# 100GBASE-KP4 transitions to data mode

(Comment #64/66)

Kent Lusted, Intel Corporation

Figure 94-7—Transition from training to data mode

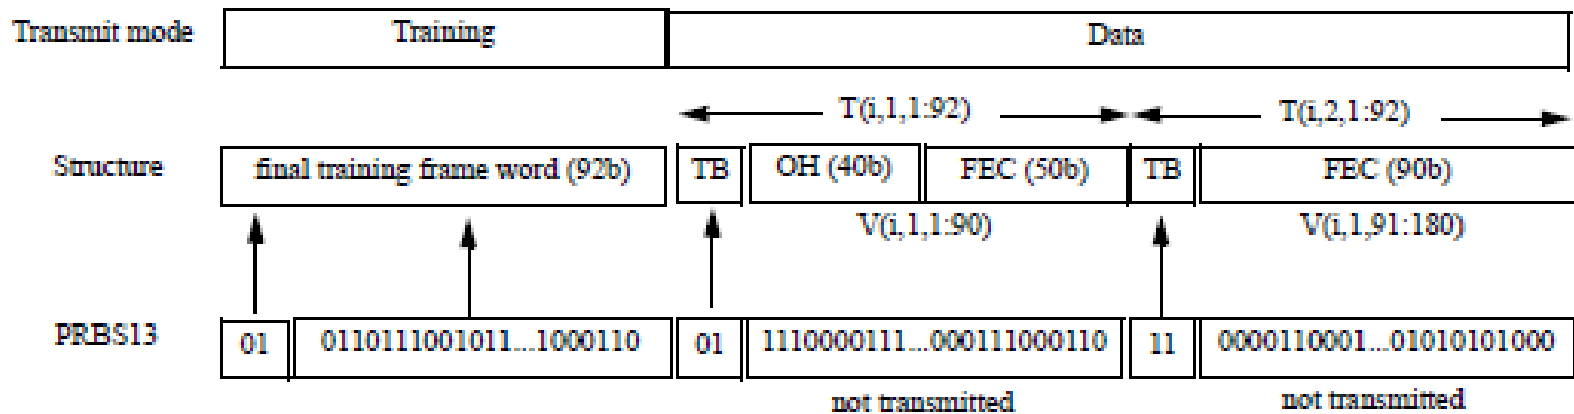
- training to data mode final TFW lane 0, (last TFW training, 1st TB92 of non-I PRBS13, 2<sup>nd</sup> TB92 of non-I PRBS13)
  - 010110111001011 ... 011000110 0111100001111 ...  
00000111000110 11000011000101 ... 00101010101000
- training to data mode final TFW lane 1,
  - 110100100010101 ... 111101101 1001101000100 ...  
11101110000011 00110000001110 ... 10111010101100
- training to data mode final TFW lane 2,
  - 010000110000110 ... 101000001 1101001101111 ...  
00101000011011 11110111001101 ... 11010000101000
- training to data mode final TFW lane 3,
  - 111010101100010 ... 111100111 1111011100001 ...  
00000111011011 01110100010100 ... 11000110110011

Figure 94-9—Transition from alert to data mode

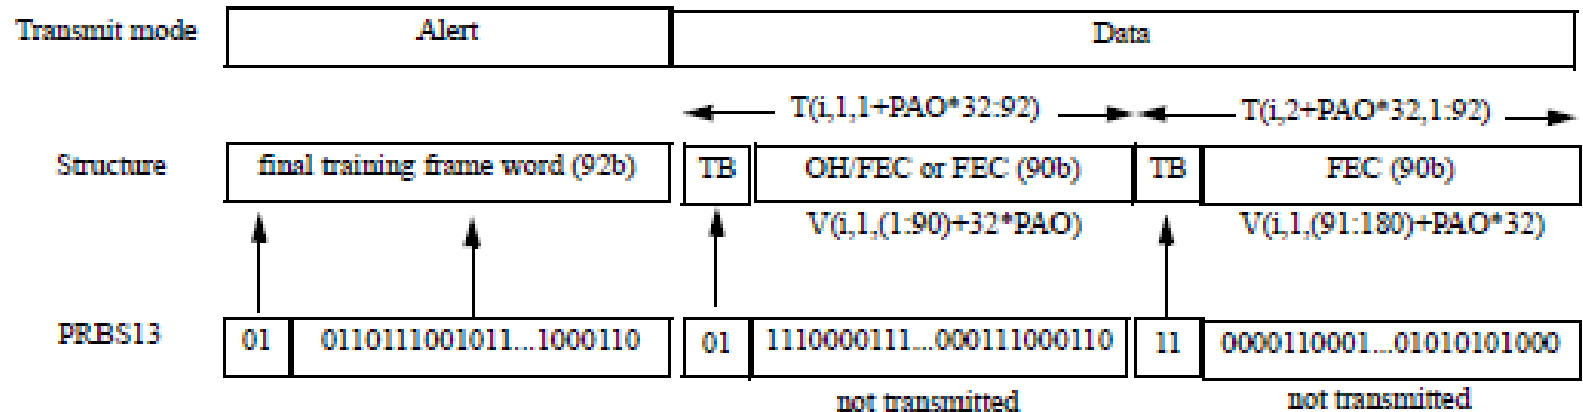
- Alert to data mode final TFW lane 0, (**last TFW training**, 1st TB92 of non-I PRBS13, 2<sup>nd</sup> TB92 of non-I PRBS13)
  - 100001000100101 ... 011000001 0011100000010 ...  
10110010010100 11100111111000 ... 01111100100001
- Alert to data mode final TFW lane 1,
  - 011111001000101 ... 000100101 1100001010011 ...  
01100101000010 10100101100100 ... 10100100110100
- Alert to data mode final TFW lane 2,
  - 011000100110101 ... 000011110 1010110000010 ...  
10111101110100 11010000100011 ... 11101000000000
- Alert to data mode final TFW lane 3,
  - 001101110011100 ... 101010100 0111111111101 ...  
11101100100110 10001111000100 ... 11100010101011
